1. **Project Address:** 800 North Block, East Washington Avenue
Project Title (if any): the Galaxie

Owner: Otto Gebhardt, Gebhardt Development
Project Name: the Galaxie Phase I & II
Purpose: UDC Design Progression Submission

Location: 800 North Block of East Washington Avenue,
Madison WI
Architect: Midwest Modern, LLC

UDC DESIGN PROGRESSION

3D KEYPLAN

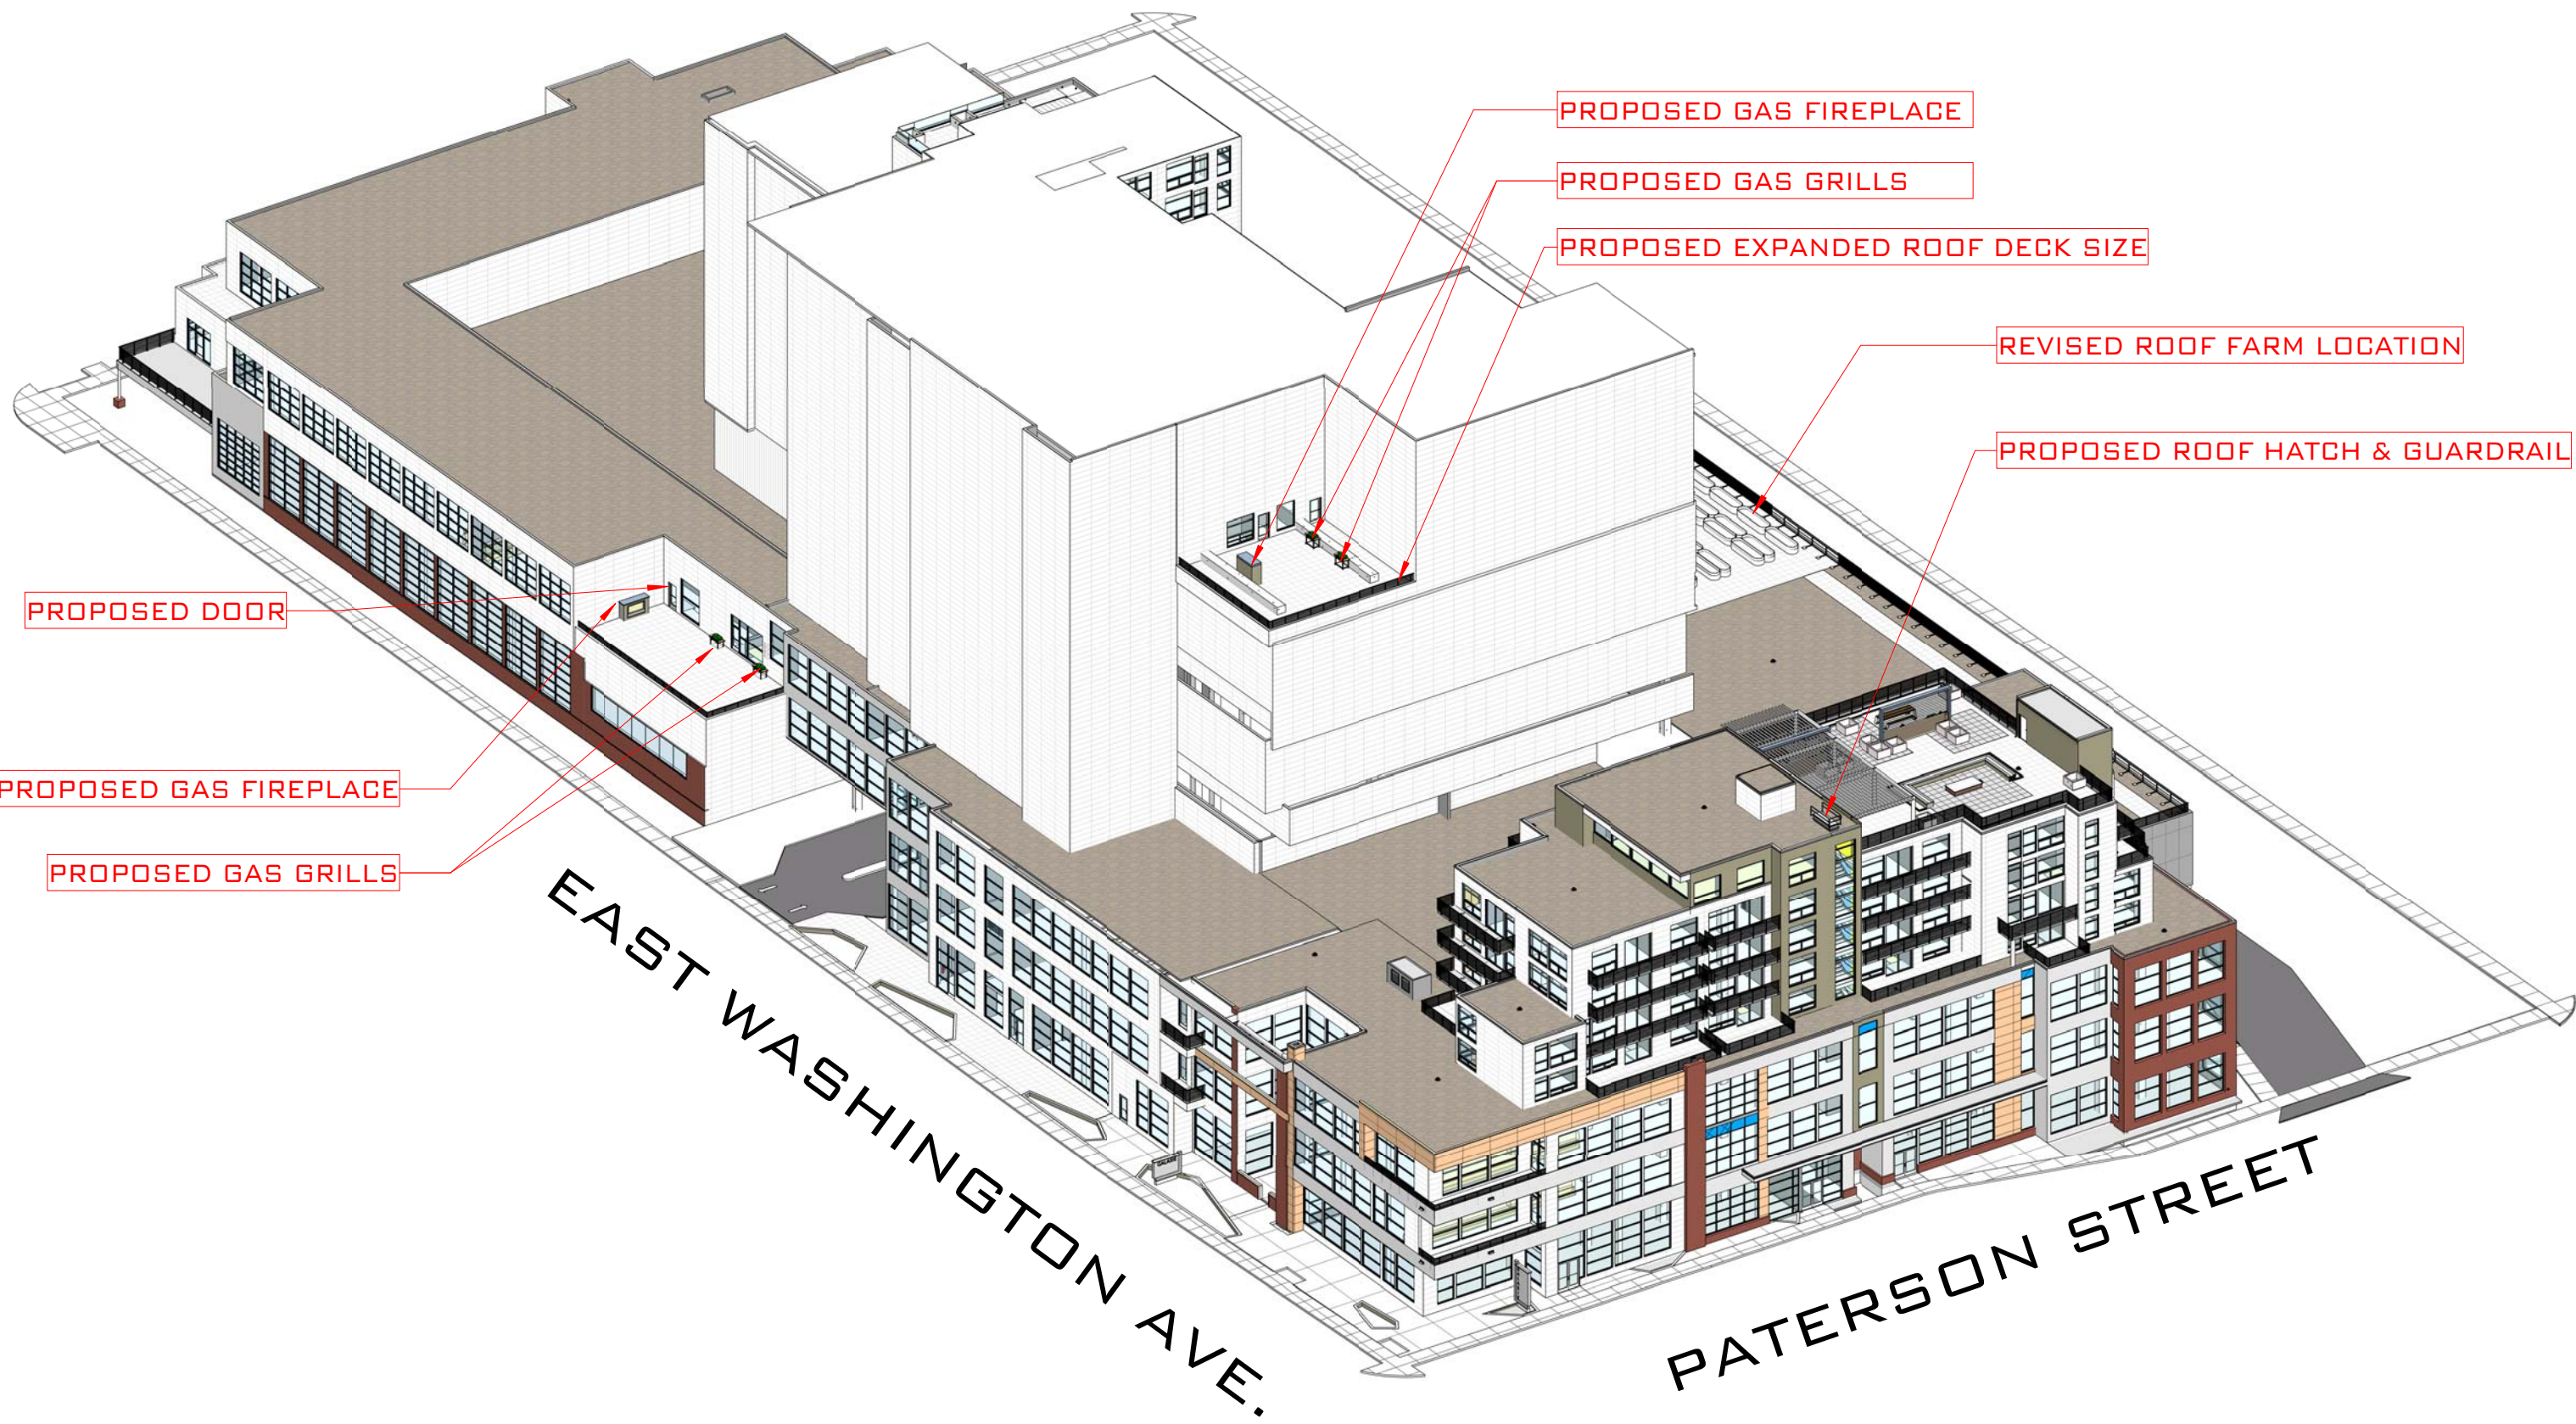
1. Added storefront door, gas fireplace, and grills at 3rd floor commercial roof deck above Festival Foods near parking garage drive.

2. Expanded roof deck area, gas fireplace, and grills at 11th floor residential roof deck above East Washington Ave.

3. Added access hatch and guardrail above Phase II tower roof.

4. Relocate roof farm above 5th floor parking roof adjacent to Phase I tower.

PROPOSED GAS FIREPLACE

PROPOSED GAS GRILLS

PROPOSED EXPANDED ROOF DECK SIZE

REVISED ROOF FARM LOCATION

PROPOSED ROOF HATCH & GUARDRAIL

PROPOSED DOOR

1 TYPICAL FIREPLACE ELEVATION
1/2" = 1'-0"

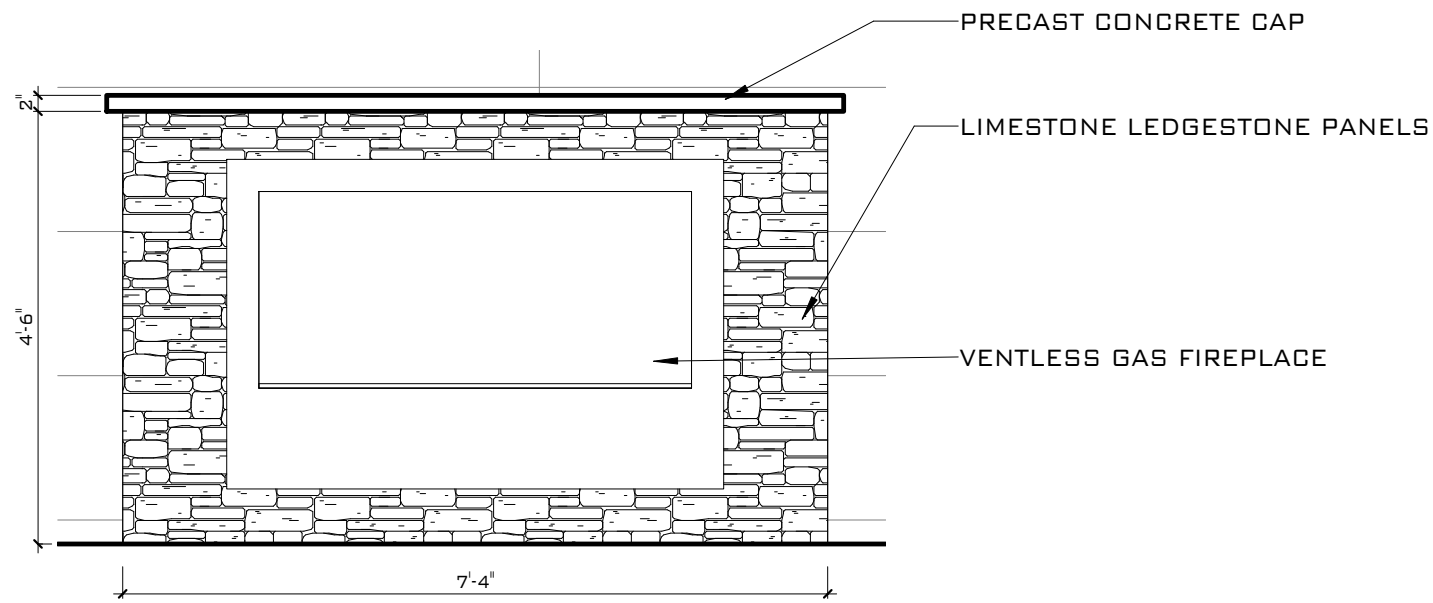
The door will be a full lite, glazed, anodized aluminum storefront door similar to adjacent exterior doors, and will add to the overall glazed area of the 3rd floor. The fireplace will be a ventless gas unit, and set in an enclosure clad with limestone ledgestone veneer with a precast cap.

The deck will be expanded to utilized the entire roof area from 750 SF to 1,500 SF. The fireplace will be a ventless gas unit, and set in an enclosure clad with limestone ledgestone veneer with a precast cap.
